# Recall Bulletin

## PRODUCT SAFETY RECALL

**SUBJECT:** Engine Compartment Fire

This bulletin is being revised to add specific, required sealant as an assembly aid to the Service Procedure, provide detailed repair information for proper application of sealant, and to adjust the Warranty Transaction Information section. Please discard all copies of bulletin 09047D.

4596904

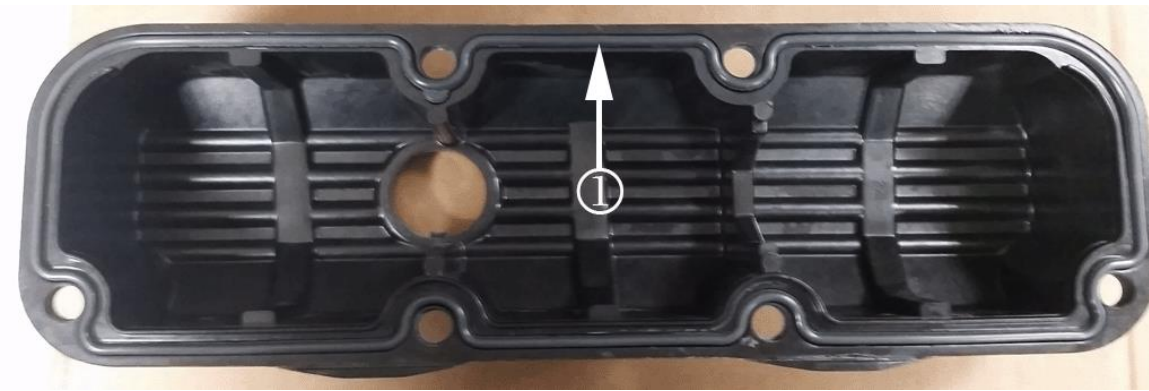
**Warning:** GM sealant part number 19333510 (in Canada use part number 10953491) or Loctite 518 is required when replacing the valve cover and valve cover gasket. Do NOT use any other sealant or adhesive as an equivalent for this repair to avoid a potential oil leak and/or fire. Paint is shown in the picture for contrast and illustrative purposes ONLY.

5. Apply a 5mm (3/16 in) bead of GM sealant part number 19333510 (in Canada use part number 10953491) or Loctite 518 in the bottom of the valve cover groove in the 14 places shown above to assist in retaining the gasket during assembly. Do NOT use any other sealants or adhesives.

2257359

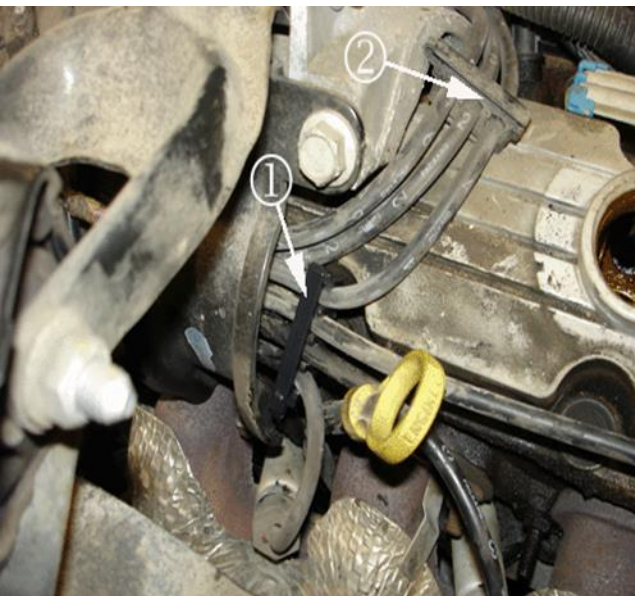
**Warning:** Ensure the new valve cover gasket is fully seated into the new valve cover groove. Use due care when installing the valve cover and gasket to the engine ensuring not to bump the valve cover or drag it over top of the rocker arms causing the gasket to come out of the groove. Inspect the mating surfaces of the valve cover and cylinder head to ensure the valve cover gasket is installed properly. Failure to do so may result in an oil leak and/or an engine fire.

6. Install a new left or front valve cover gasket (1) into the new valve cover and make sure that the valve cover gasket is seated properly in the valve cover groove.
  - 6.1. Install the six valve cover bolts and the six grommets into the valve cover.
  - 6.2. Apply medium strength thread lock compound (blue) to the six valve cover bolt threads.
  - 6.3. Install the NEW valve cover and gasket (1) to the cylinder head.
  - 6.4. Tighten the valve cover bolts to 10 Nm (89 lb in).
  - 6.5. Verify that the valve cover gasket is properly installed (see the warning above).
7. Install the 1-3-5 spark plug wires to the ignition coils.
